Access Compliance Report Public Rights-of-Way (Curb Ramps)

Main Street: RED_HILL_AVE		Cross Street: SE_SKYLINE_DR		Location:	NW
ADA ID: RPRK211012114301	Ramp Type: Type 4 - Parallel	Initial Pass/Fail: Fail	Overall Compliance: No	Severity Score:	15
Codes/Mitigation Info/Possible Solution			Field Measurements/Component Compliance

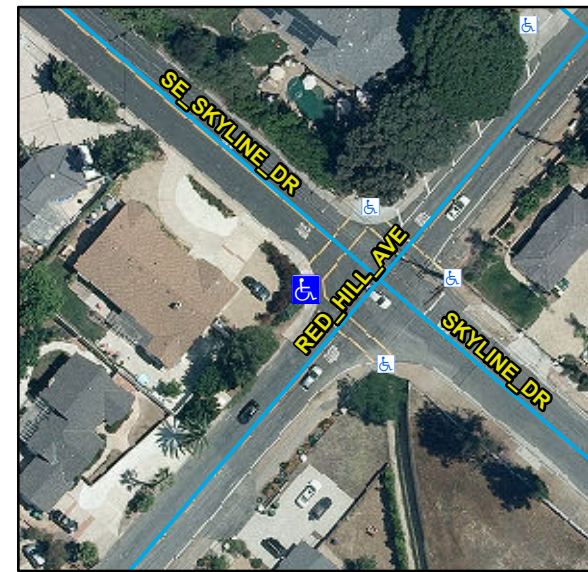
Compliance	Description	Data	Compliance	Description	Data
N/A	Ramp Length LT (in)	98	N/A	Ramp Length RT (in)	120
Yes	Ramp Width LT (in)	48	Yes	Ramp Width RT (in)	48
Yes	Ramp Run Slope LT (%)	6.2	No	Ramp Run Slope RT (%)	8.8
Yes	Ramp Cross Slope LT (%)	1.4	Yes	Ramp Cross Slope RT (%)	0.8
N/A	Landing Present	N/A	N/A	DWS Provided	N/A
N/A	Landing Length (in)	N/A	N/A	DWS Contrast	N/A
N/A	Landing Width (in)	N/A	N/A	DWS Length (in)	N/A
N/A	Landing Run Slope (%)	N/A	N/A	DWS Full Width	N/A
N/A	Landing Cross Slope (%)	N/A		DWS Offset Type	N/A
N/A	Landing Movement Obstructed?	N/A	N/A	DWS Offset Left (in)	N/A
	Landing Movement Type	N/A	N/A	DWS Offset Right (in)	N/A
N/A	Landing Shared	N/A			
N/A	Clear Space	Yes			
N/A	Clear Space To Crosswalk (in)	48			
N/A	Marked Crosswalk 1	Yes	N/A	Marked Crosswalk 2	Yes
	Crossing 1 Direction	SE		Crossing 2 Direction	NE
	Marked Crosswalk 1 Width (in)	120		Marked Crosswalk 2 Width (in)	144

Remove & Replace Curb Ramp With Two New Directional Ramps or Equivalent.

R304.3.2, STD 1115
